Staff Report & Recommendations

Lockwood Meadows Subdivision Lot 24 Accessory Dwelling Unit

Type II Review

(2024-025-ADU) October 9, 2024

Site Plan

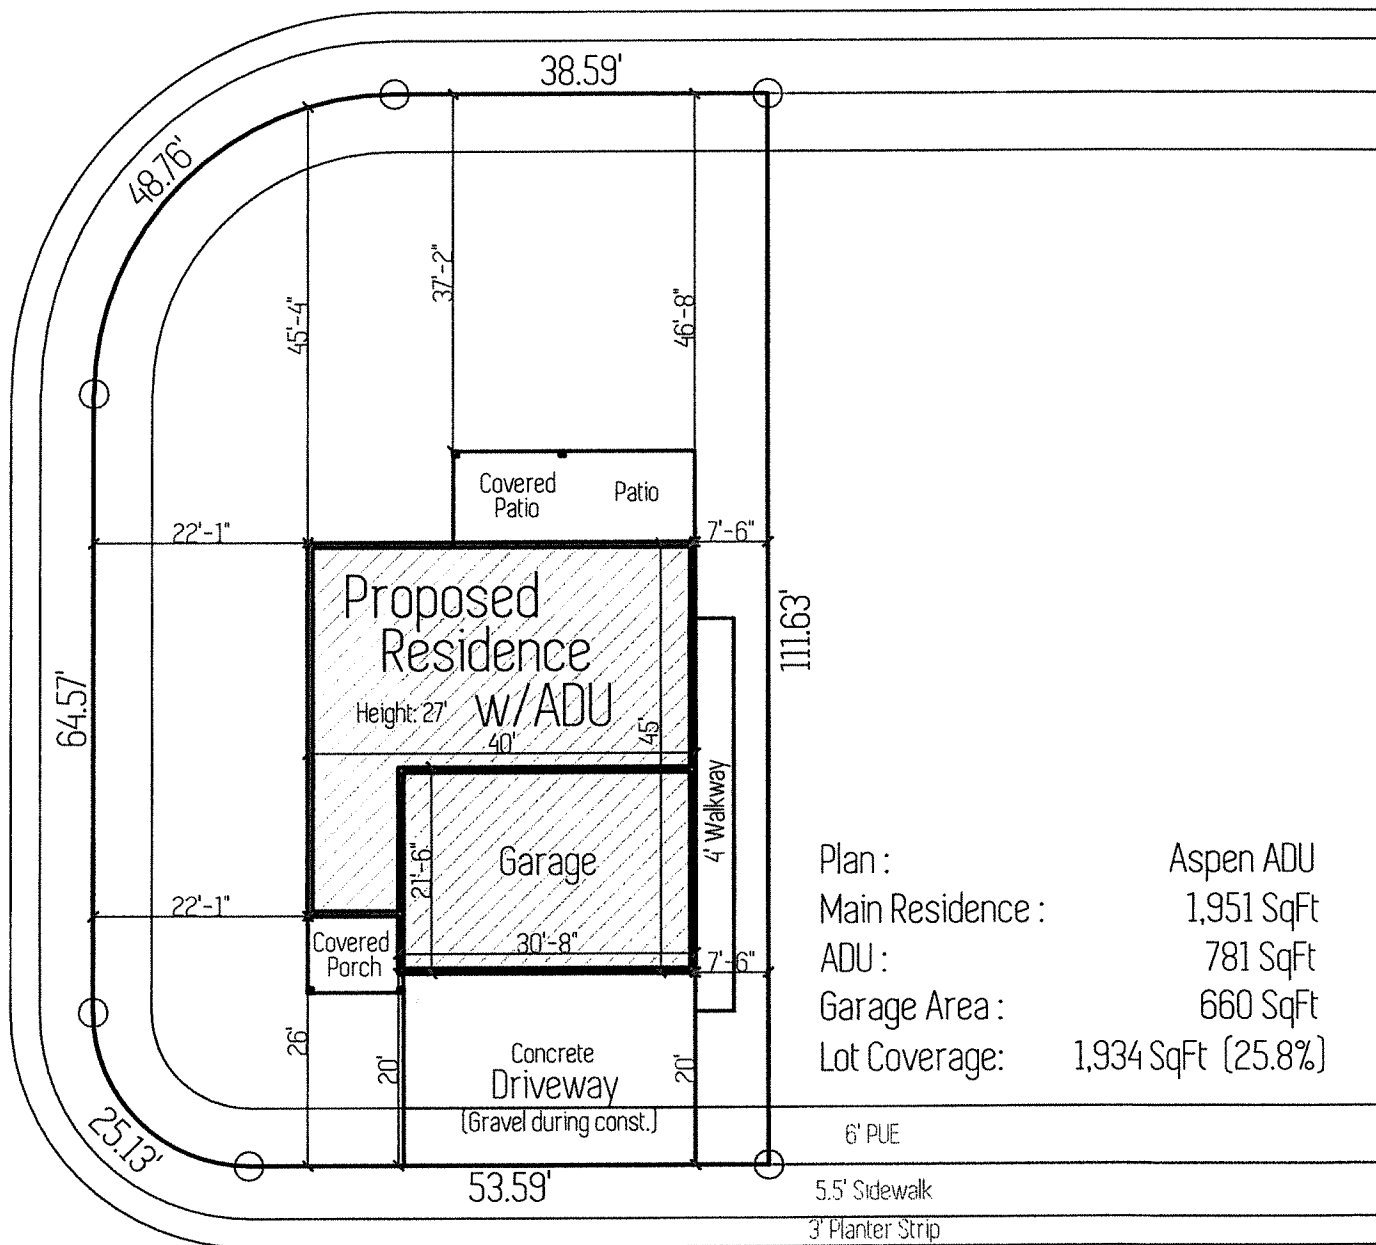
Findings: The proposed attached ADU is located on the east side yard of the primary residence. It will be setback approximately ten (10) feet from the interior property line. The setback criteria meets the requirement.

Findings: As indicated in the provided plans from the applicant, the ADU will take access from the three-car driveway.

Condition 4: The applicant shall construct the driveway improvements as shown on the approved site plan and meet International Fire Code fire access standards prior to issuance of the occupancy permit.
